BID ADDENDUM NO.1 ISSUED 3/27/24

ROOF REPLACEMENT AT THE FOLLOWING SITE:

ELMHURST ELEMENTARY SCHOOL – 5080 Elmhurst Street, Ventura, CA 93003

Project/ Bid No.: BID #E18-24

OVERALL
CAMPUS PLAN

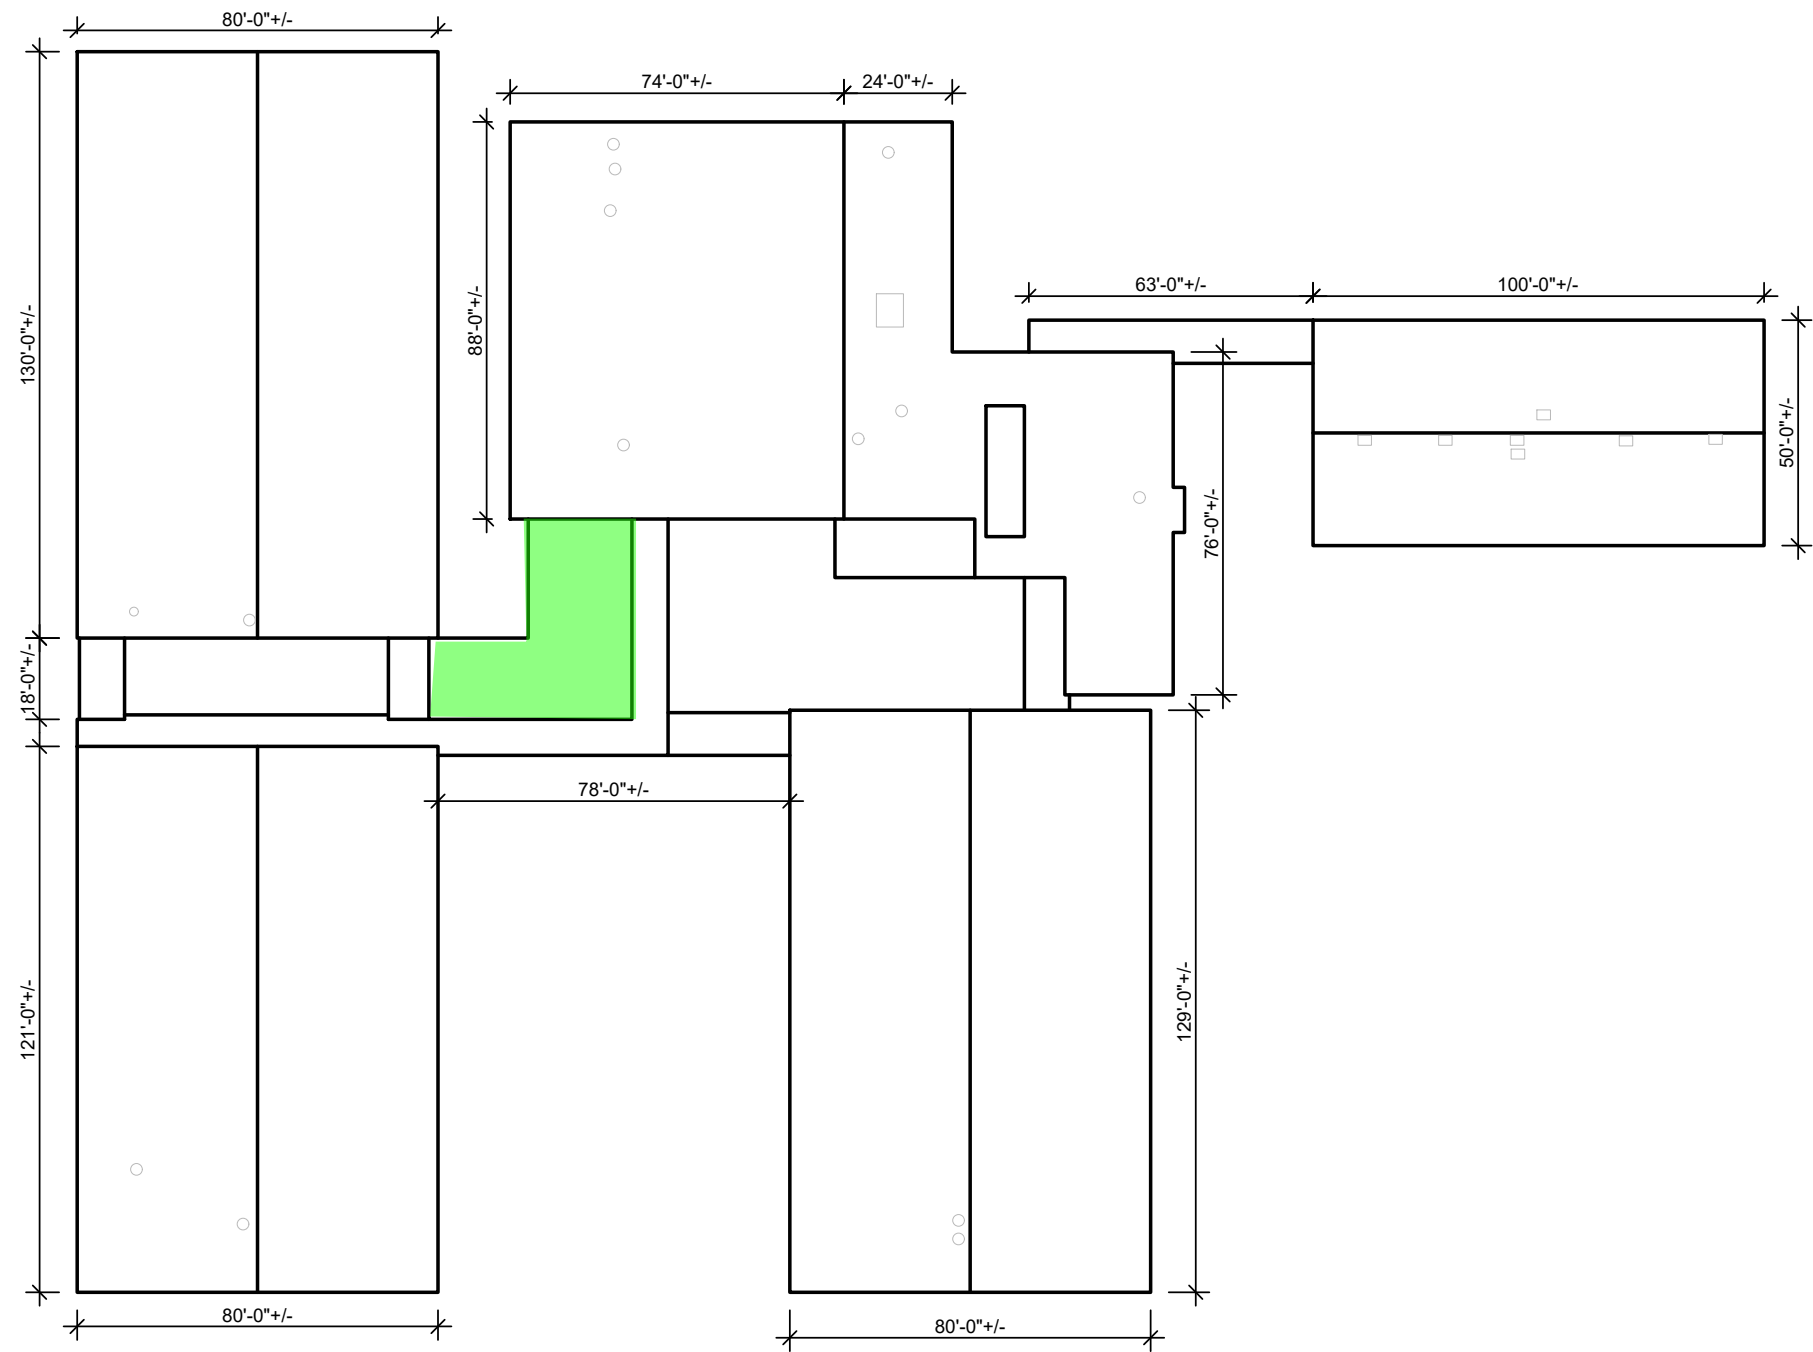
- I. REVISED SPECIFICATIONS AND DRAWINGS
 - a. Site Plans and Drawings
 - i. The roof section highlighted is to be added to the reroofing scope. See
the enclosed overview and roof plans with the highlighted green roof
section.
